CONSTRUCTION SUMMARY

Charisma Condominiums - Granerola Residences Ltd.

C 984
TOWER SUITE
SOUTH TOWER
9' CEILING

Unit No. $\underline{28}$ Level No. $\underline{4}$ Suite No. $\underline{435}$

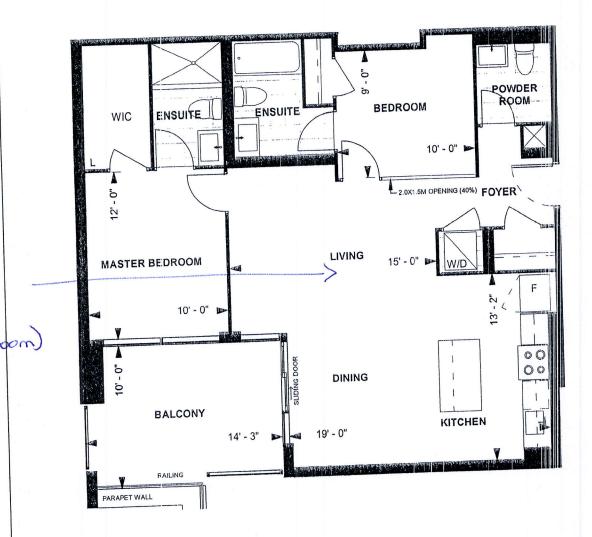
1 - ADD LIGHT IN LIVING ROOM	
09Feb22 Note:	는 소스 회원에 그렇게 되다.
